### Re: Narrative of Submittal Revisions due to Plan Commission Comment

**203 S. MARION ST.** 2021 02 16 2000.00

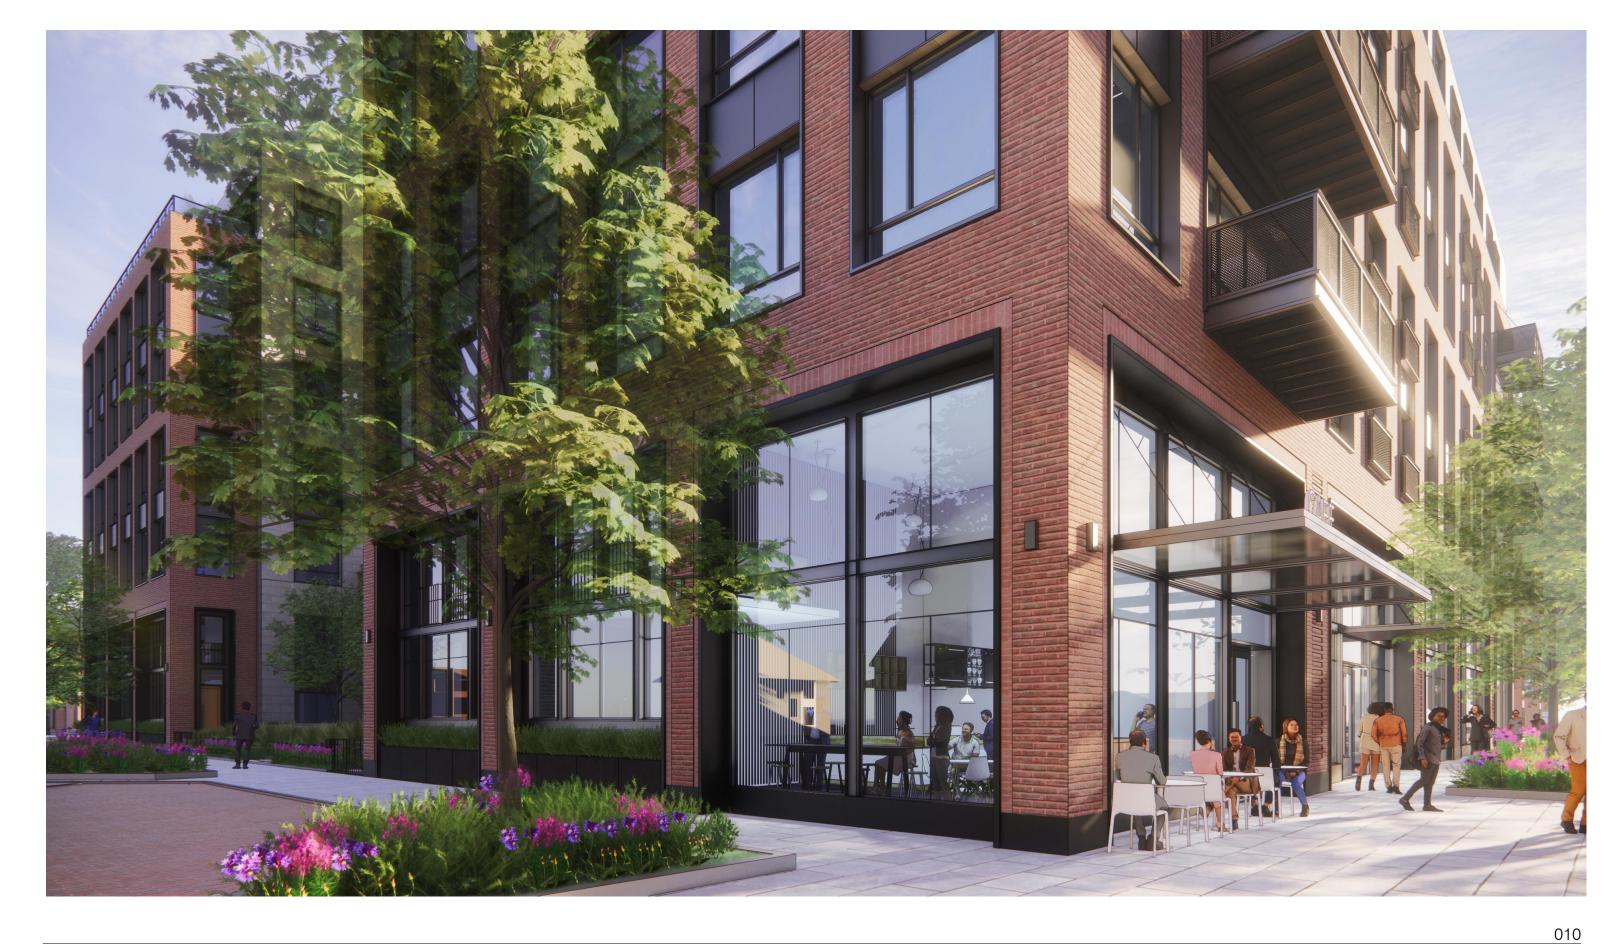
A few Commissioners suggested that we provide a more "eclectic" treatment or added detail to the façade on the Marion Street and Pleasant Street elevations. As a result of this feedback, the design team revised the brick detailing around the window openings at the first and second floor. The revised renderings include brick banding surrounding the windows and brick reveals at the vertical masonry elements on the north and east façade.
